TALLAWONG STATION **PRECINCT SOUTH**

ADDENDUM URBAN DESIGN REPORT

Rev. F_20.01.2021

AMENDMENTS TO BUILDING ENVELOPES FOOTPRINT & STOREYS

SITE 2 BUILDING HEIGHTS

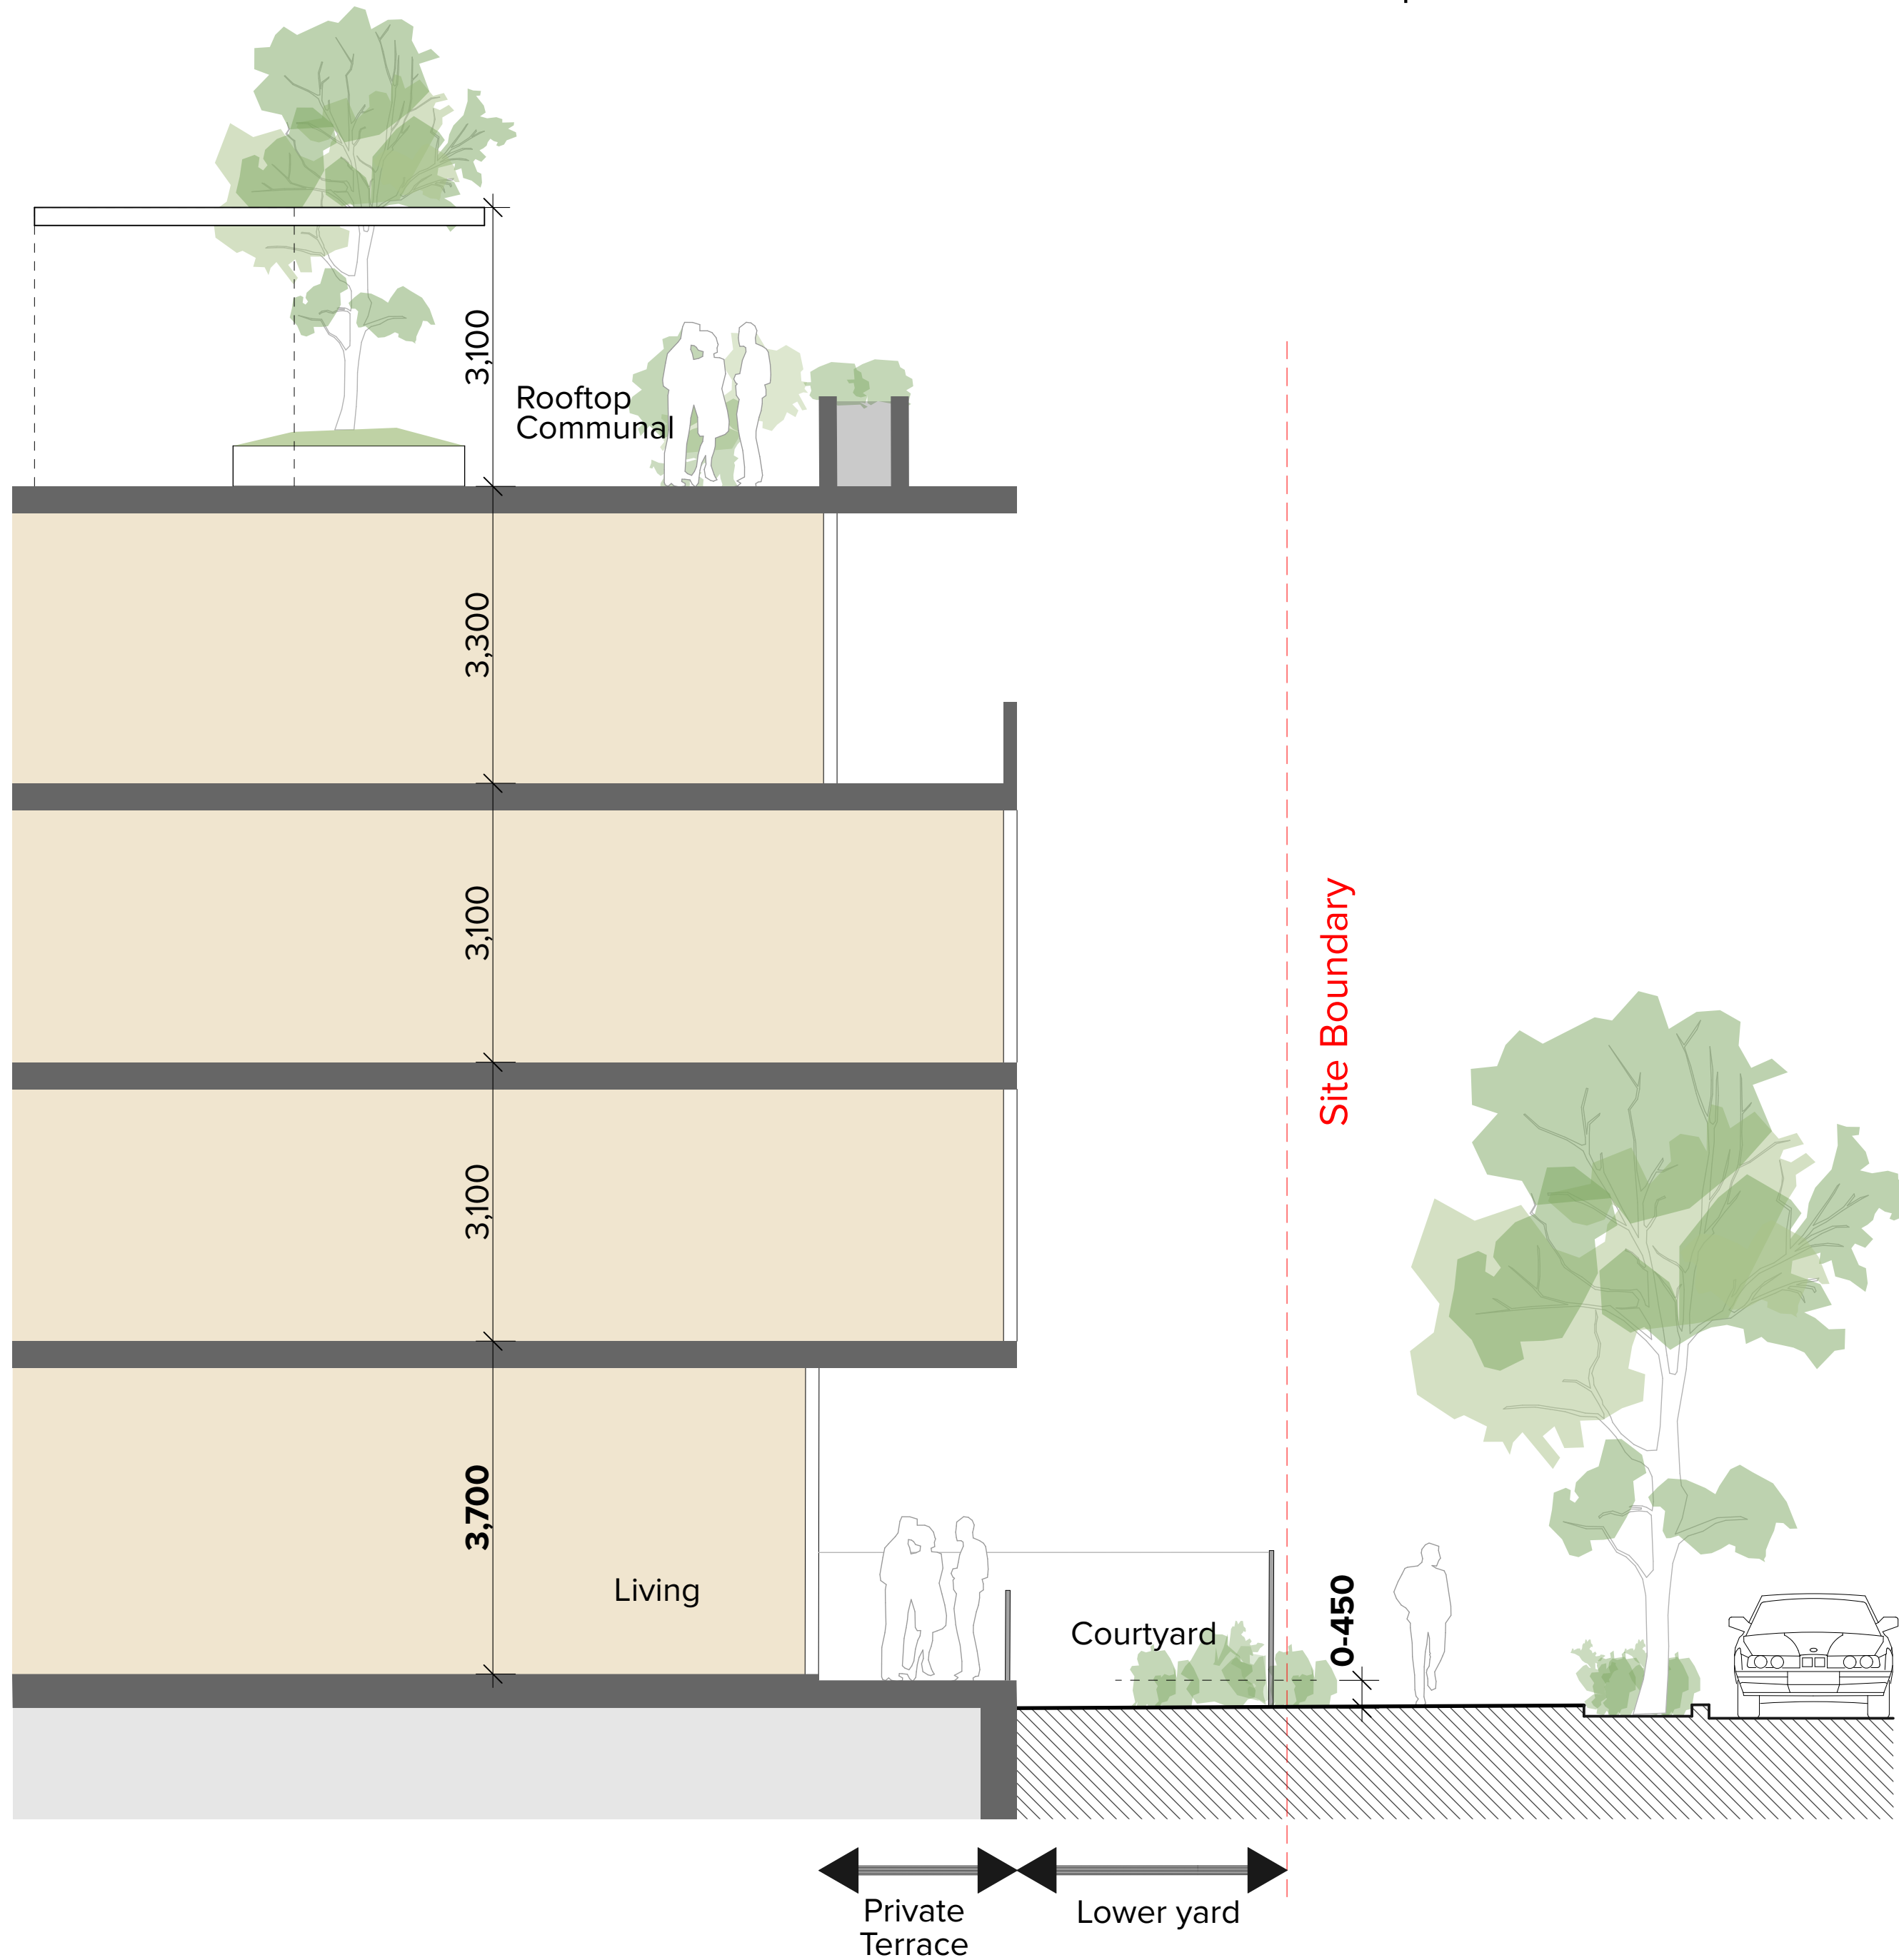
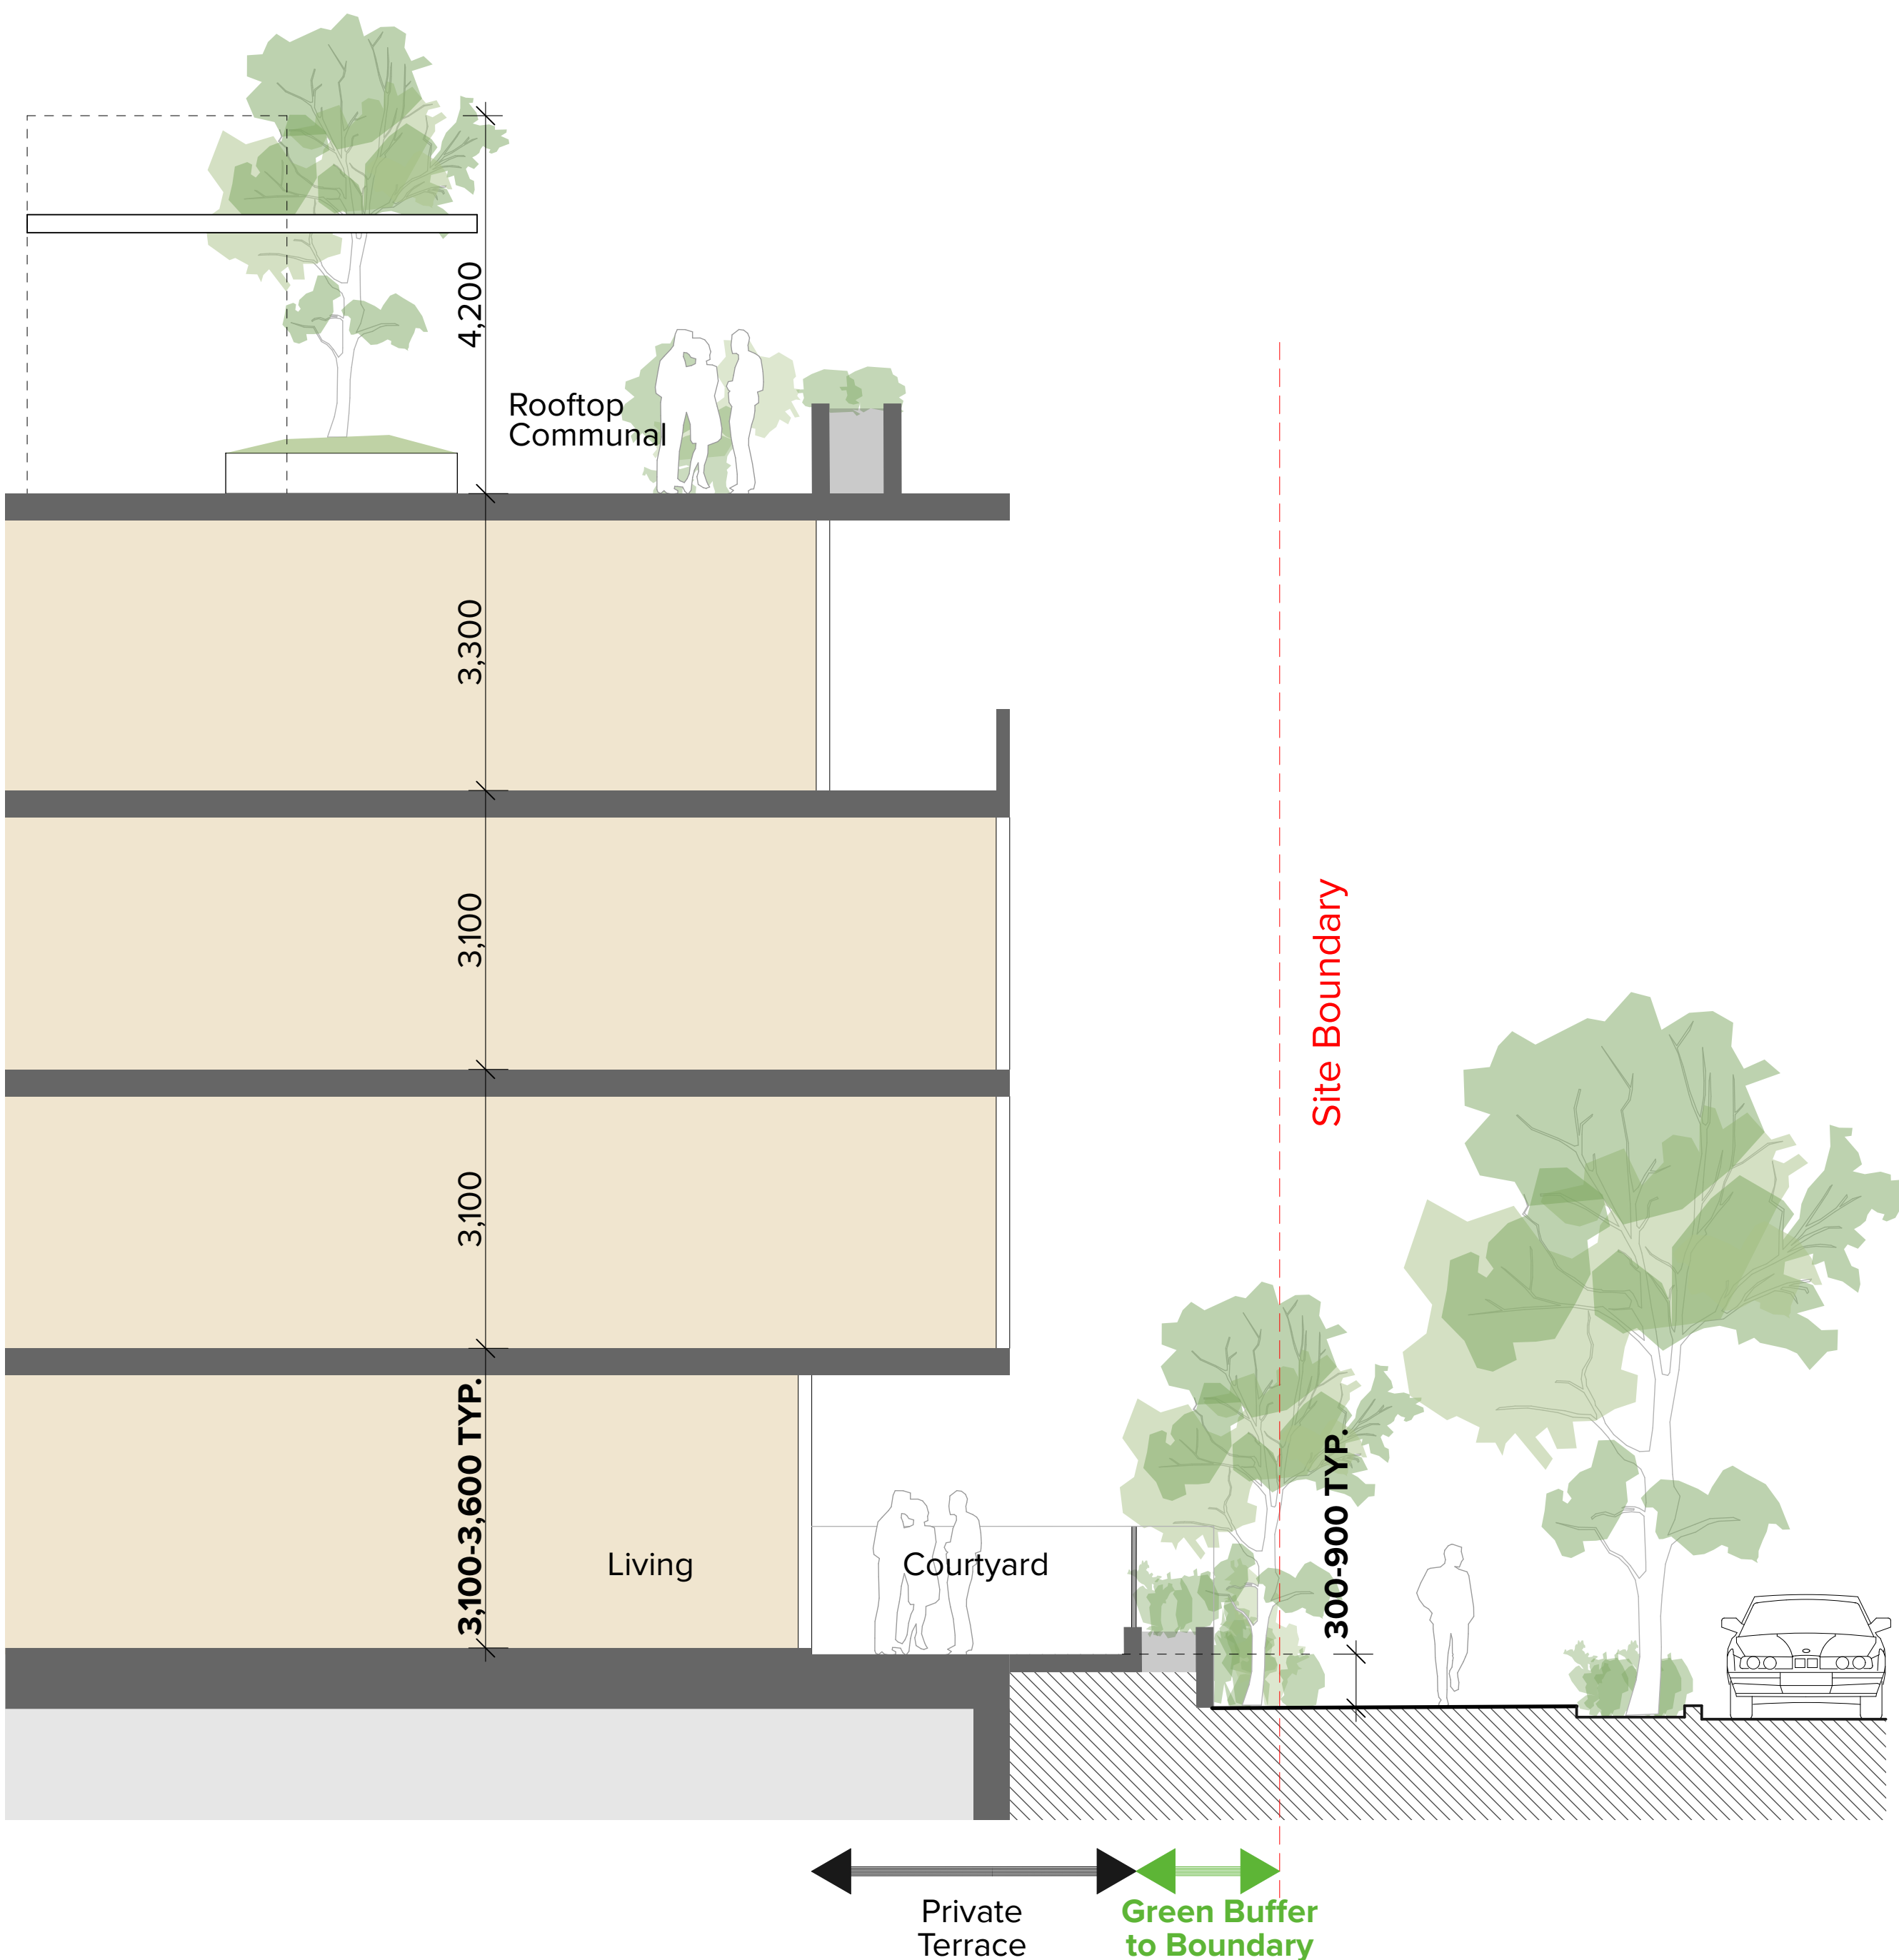
The Approved SSDA allowed for a 3.7m high ground level (floor to floor) to provide an "adaptable residential" level. Given the large provision of non-residential uses (9,000sqm GFA) within Site 1 "Town Centre" it is not considered necessary to provide for future adaptive re-use within the Site 2 "Residential neighbourhood".

Notwithstanding the above, the natural fall of the land allows for a range of heights within the ground plane from 3.1m to 3.6m (floor to floor).

The ground level apartments are proposed to have their floor level set at 300-900mm above the footpath level (typically). The courtyard is proposed to be elevated to provide a consolidated open space, as opposed to the split scenario proposed in the SSDA. This allows for amenity and privacy for residents while maintaining passive surveillance and an active public domain.

The overall height of the building is slightly lower than the SSDA, though the height of the lift overrun has been increased to reflect manufacturers requirements.
